# Lufthansa Systems FlightNav

## ***General Navigation Data Information***

**Issue 1/2015**

### **Potentially wrong turn during SID and missed approach: all Honeywell FMS types**

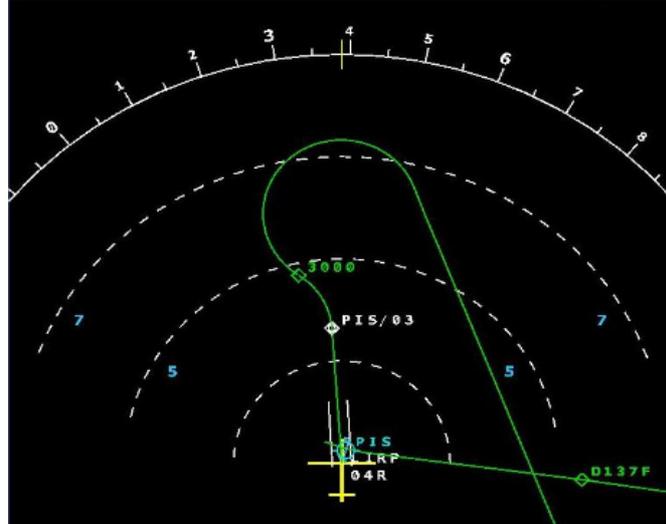
Though there have been no reported cases of turning the wrong direction, Honeywell has established that under rare conditions, an incorrect turn direction could be performed by the FMS.

See below an example of a potentially affected procedure. In this example, the erroneous turn may be seen on ground whereas on other procedures it may only be seen after takeoff i.e. after the prediction updates.

This potential issue will be mitigated by either a) modification of the Navigation Database coding (to be harmonized with the FMS operation), or b) by removing procedures from the Navigation Database.

Honeywell has provided a list of potentially affected procedures to Lufthansa Systems, based on the data of cycle 1503. This was analyzed and – in order to avoid the removal of the procedure – alternative codings have been established. Mainly, the critical CA/FA/VA Path Terminators were replaced by either FM or VM (Fix-to-manual-termination or Heading-to-manual-termination) Path Terminators. This means that the crew has to manually intervene and terminate these legs and activate the next leg. Nevertheless, the entire procedure remains available to the crew, including all transitions.
